10 Clorane Gardens
London, NW3 7PR

Basement Impact Assessment
Audit

London Borough of Camden

Project Number: 12336-11

BASEMENT PLANS. DRAWING no. 4000. 1:200@A3

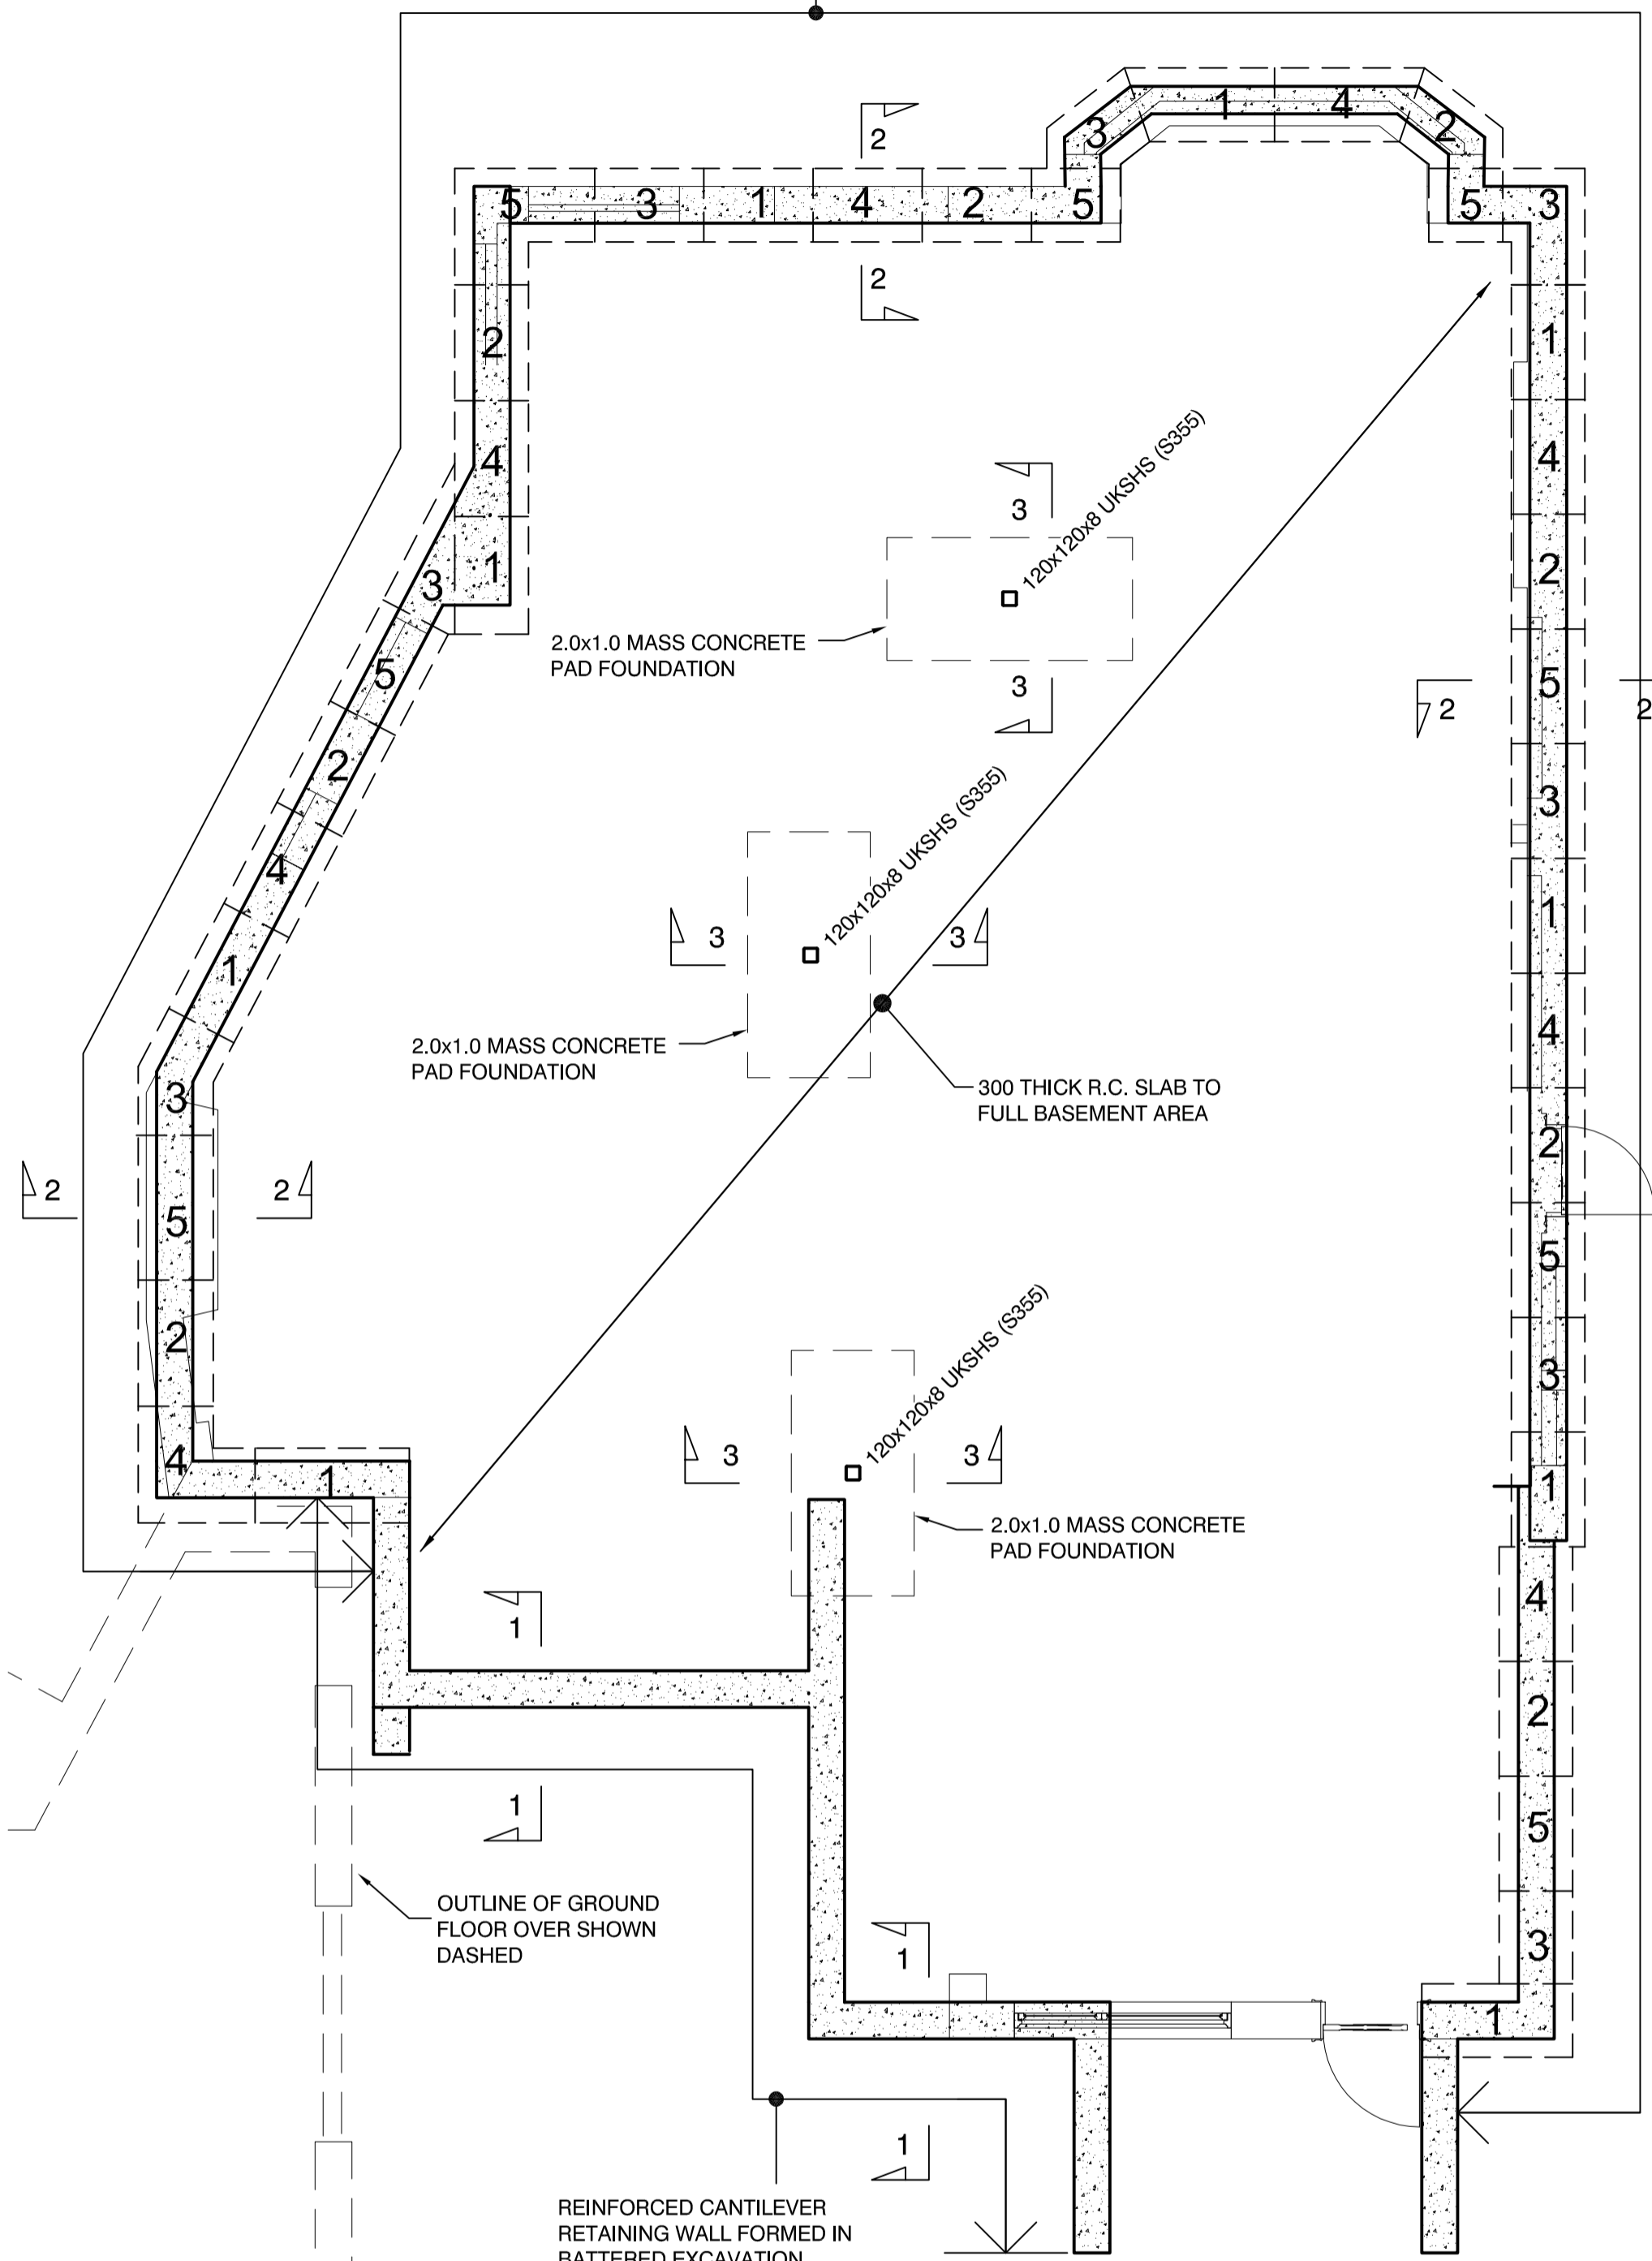
- 4.9. First Steps Ltd (consultation response 9th February 2016 on behalf of No 12 Clorane Gardens) suggests that the potential effects on the groundwater flows of the new basement in combination with the existing basements in the vicinity has not been appropriately assessed. The site investigation for No 10 has shown that the underlying soils are likely to be of low permeability and, therefore, groundwater flows will be slow and this appears to be supported by the differences in the water levels measured in the two boreholes. The presence of basements on the opposite side of Clorane Gardens is raised in the First Steps Ltd consultation response, however, the presence of an existing significant upstream obstruction to groundwater flows will tend to reduce the potential effects of the proposed No 10 basement. Reference was also made to the '*potential for creating an underground dam that extends from the boundary of No.16 to that of No.8.*' No 8 was understood to have a small boiler room below ground level with No 12 indicated to contain a basement separated from the proposed basement to No 10 by a small gap. The presence and extents of basements to Nos 14 and 16 was not confirmed. Following the initial audit, a plan confirming the absence of basements beneath No 8, 14 and 16 Clorane Gardens has been provided and is included in Appendix 3.

- 5.7. The site investigation has shown that groundwater is present within the underlying silty clay soils but also that the permeability of these soils is likely to be low. A plan indicating the presence or absence of basements beneath the neighbouring properties with the extents and depths indicated where present to demonstrate the existence of adequate flow paths for groundwater was requested following the initial audit. This has now been provided, although the depths are not indicated and it is stated the information is from publically available sources rather than site surveys.

**NB: neighbouring basement drawings are based on publicly available drawings and not site surveys. Internal walls have been ignored for the purposes of the BIA.*

7	Plan showing basements to adjoining properties to demonstrate adequate groundwater flow paths	Drawing attached from Kyson: - 460-15 Neighbouring Basements
---	---	---

Drawing
Basement Showing Underpinning Sequence and Details

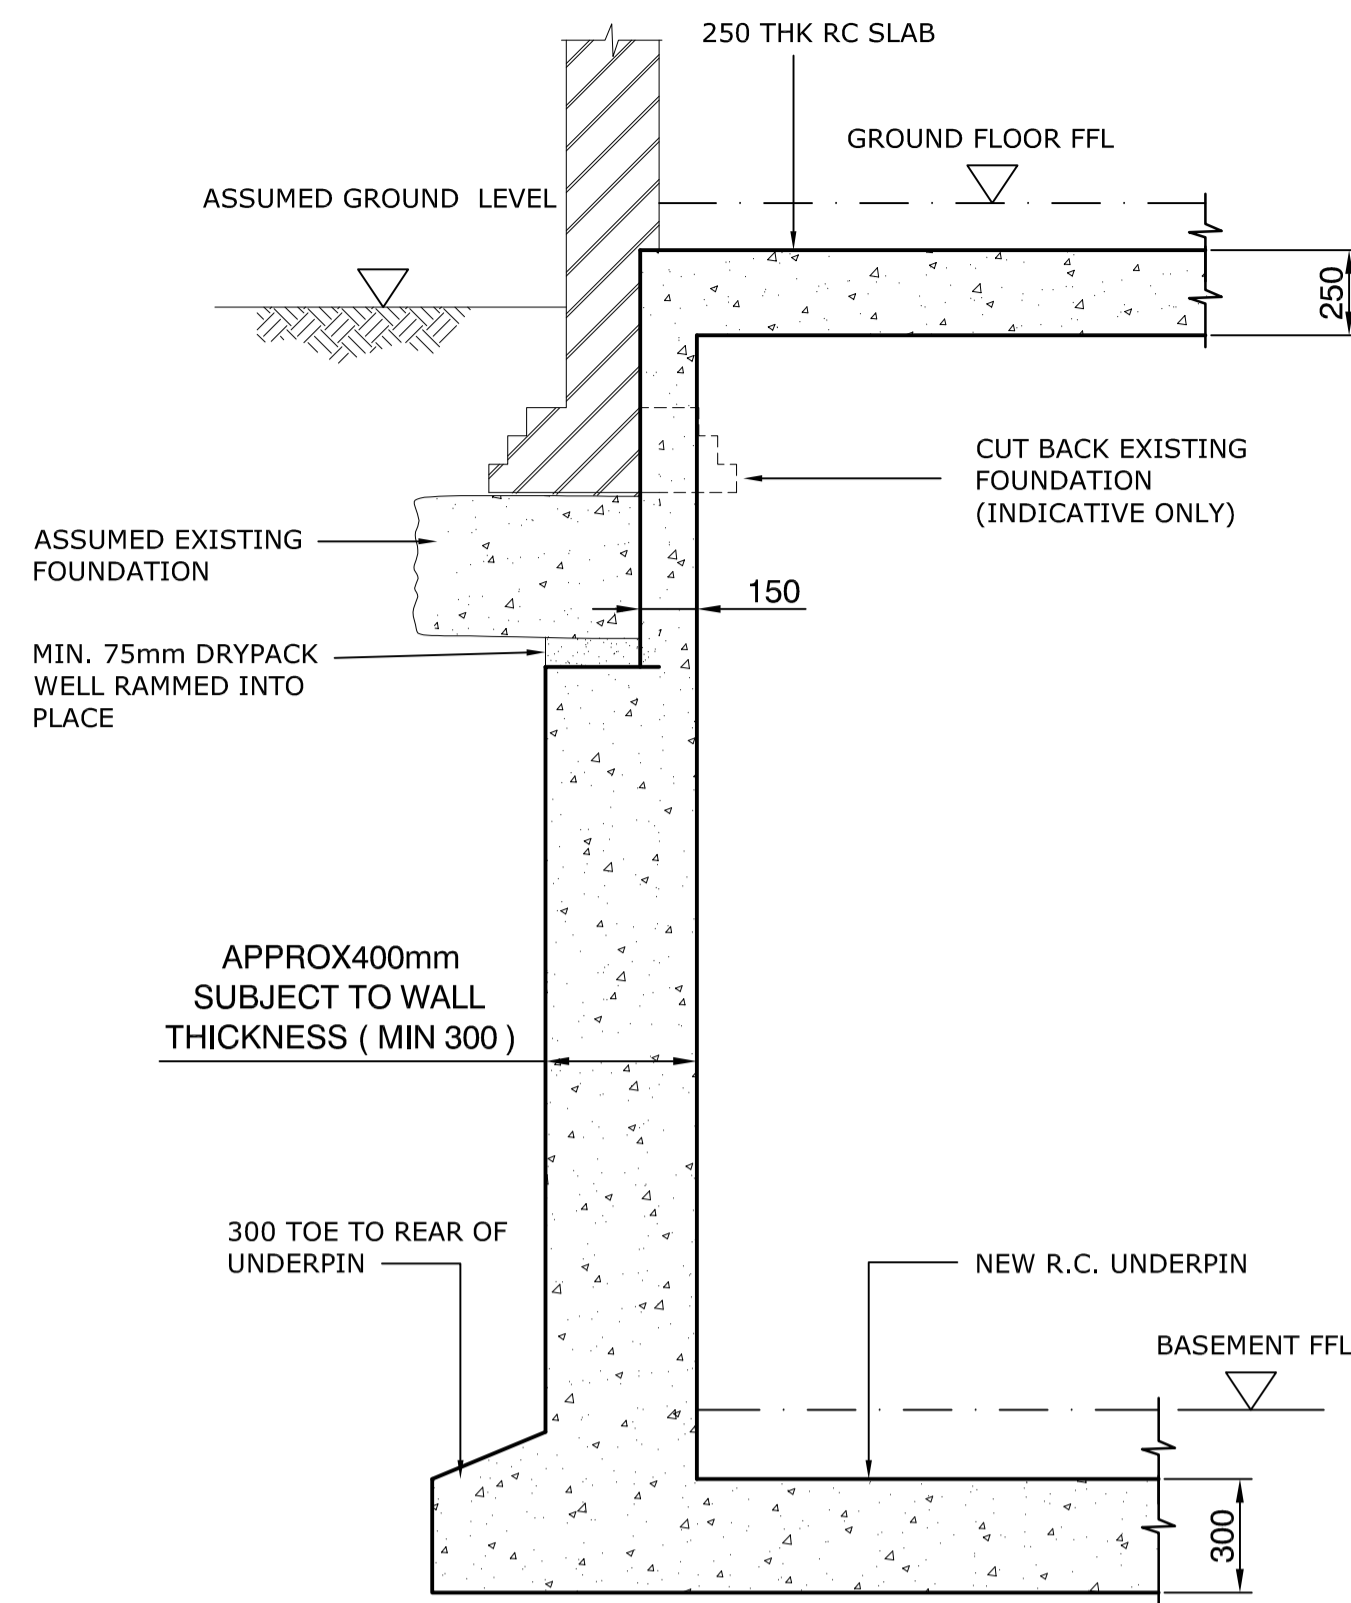
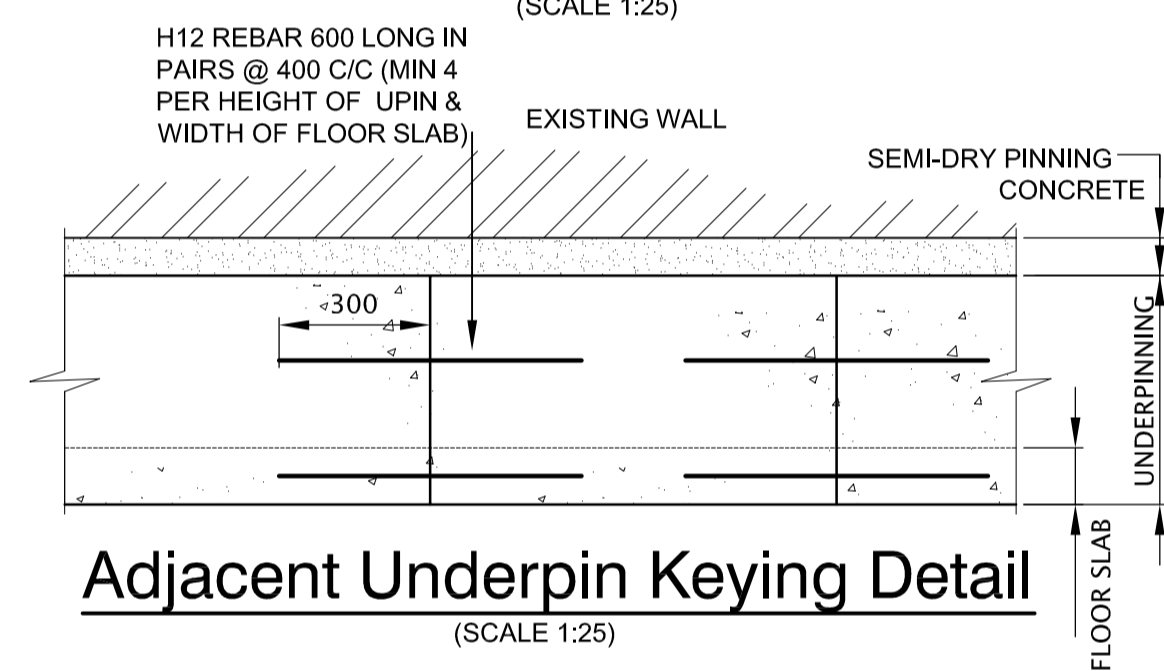
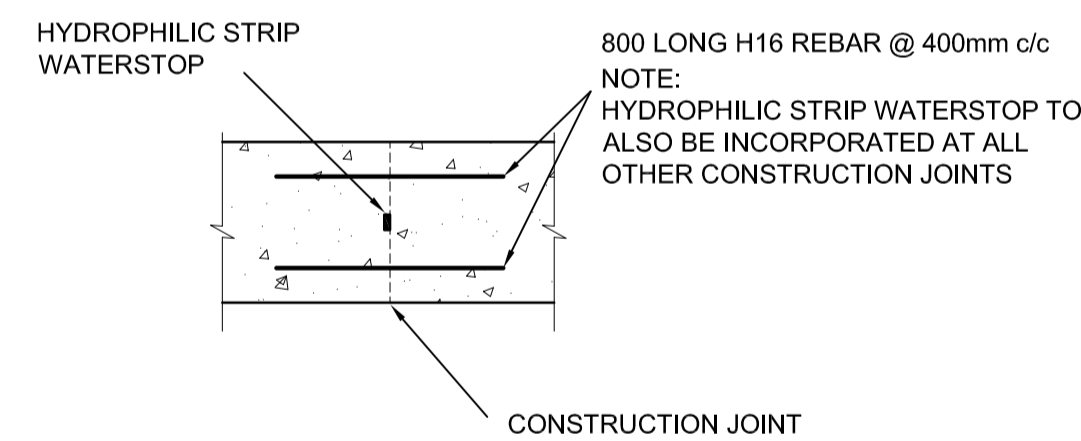
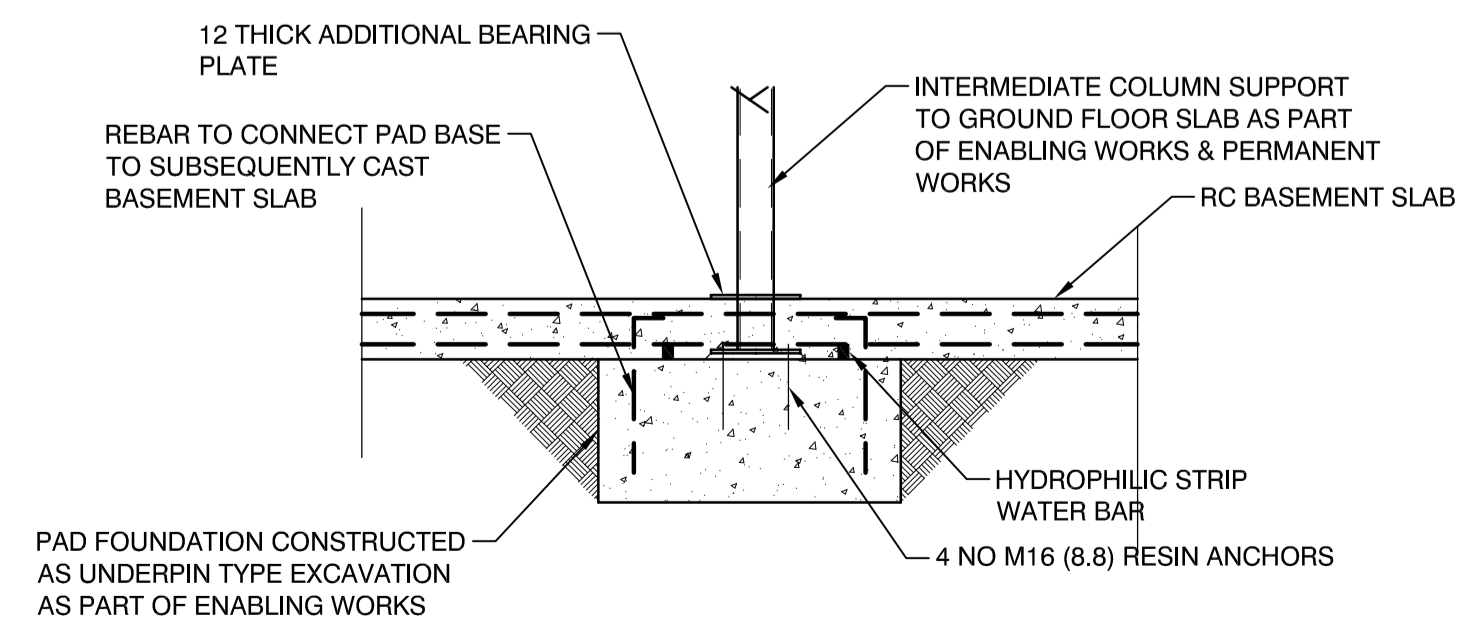
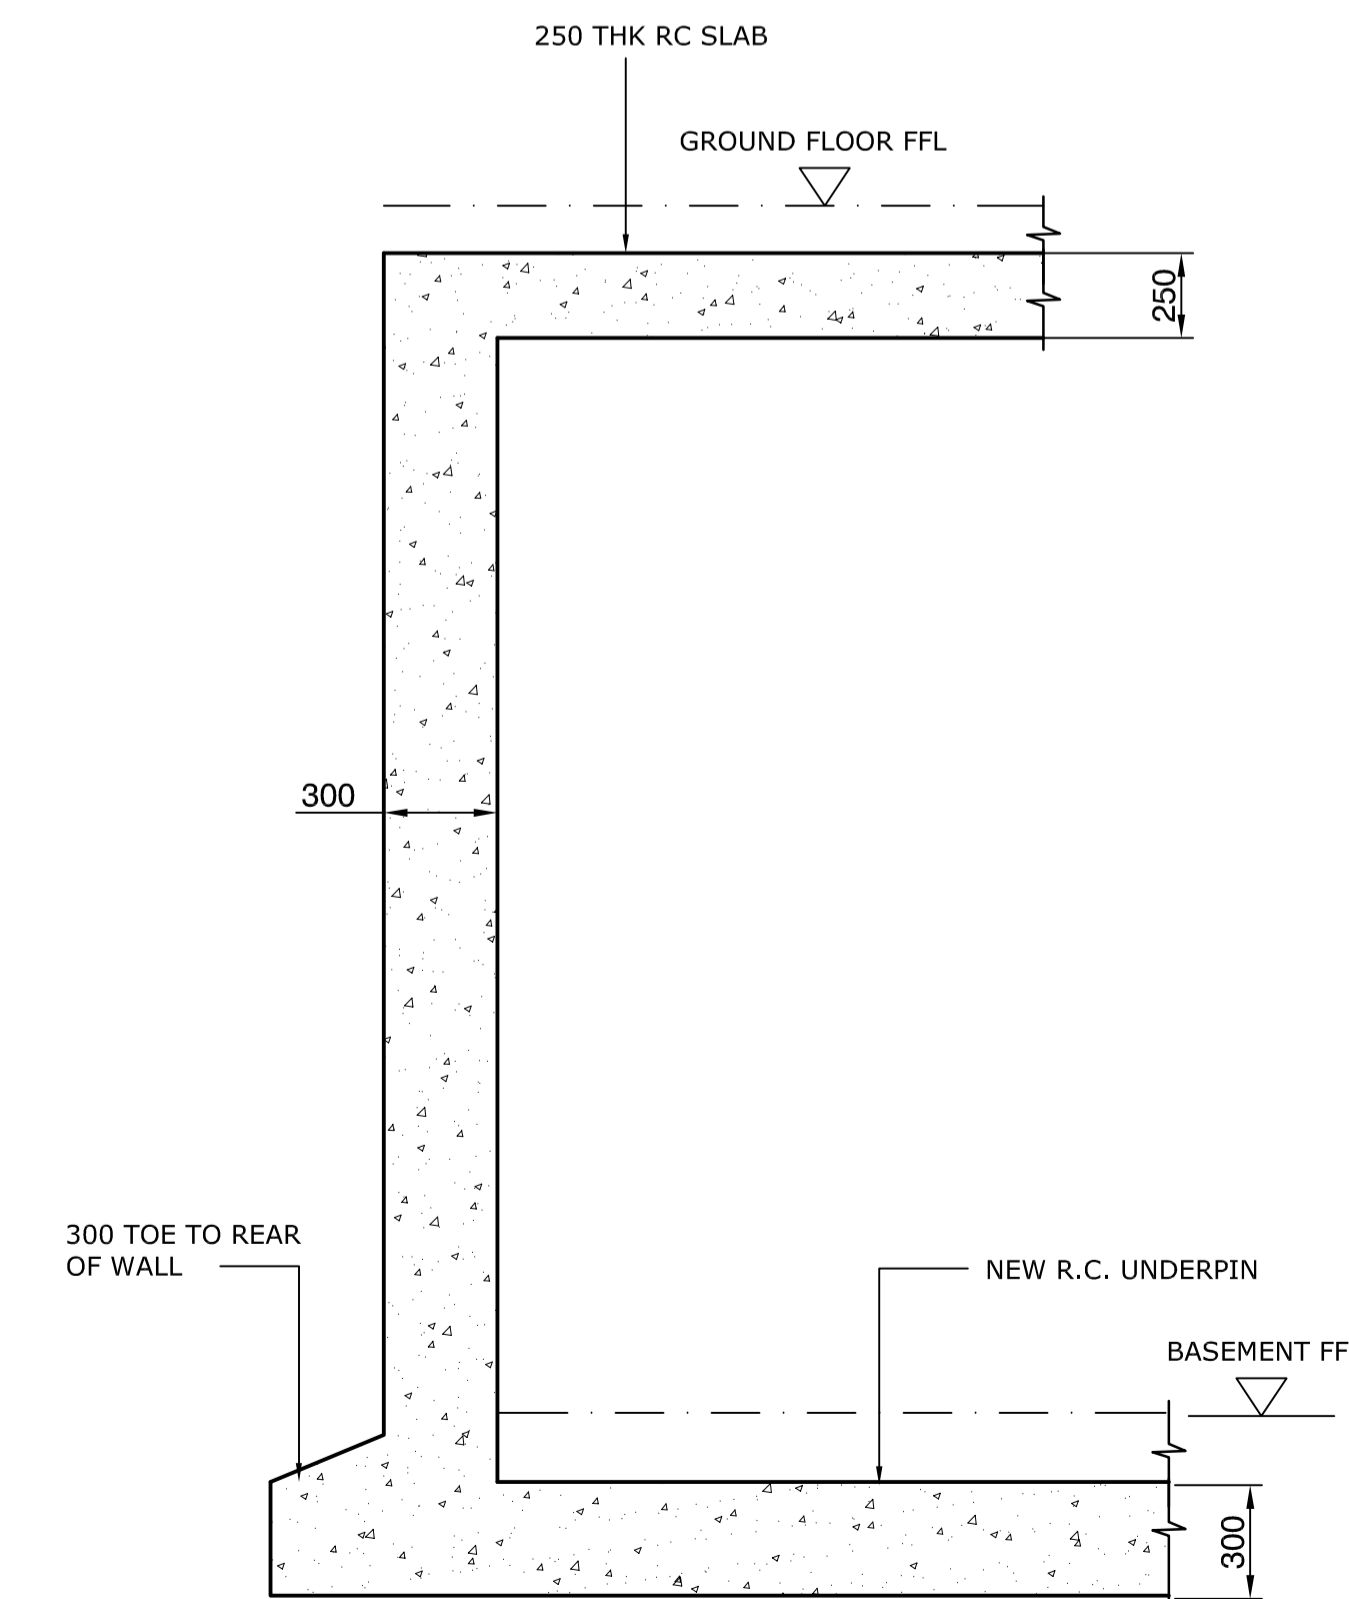
- 4.13. The formation of the basement requires a combination of underpinning to the perimeter walls, new internal columns on isolated pad foundations and reinforced concrete walls formed in open excavations. The BIA identifies that temporary propping to the perimeter retaining walls (underpinning) is required until the construction work is complete and that face support to excavations will be required within the Made ground and Claygate Member, however, no proposals were included and it was stated that all temporary works designs are to be undertaken by the works contractor. Reinforcement details for the reinforced underpins are provided, however, no structural calculations were provided to justify this information or to demonstrate the stability of the underpins in the temporary condition. The BIA notes that the presence of laminae and associated groundwater seepages may require additional measures and recommends that the excavations are to be inspected by a competent person at the start of every shift and significant change in the geometry of the excavations. Calculations have now been provided together with drawings indicating the underpinning bay and construction sequence respectively.

- 5.4. Calculations have now been provided together with drawings indicating the underpinning bay and construction sequence respectively as requested following the initial audit to demonstrate how the stability of the works is to be maintained and support is to be provided to the adjoining properties.
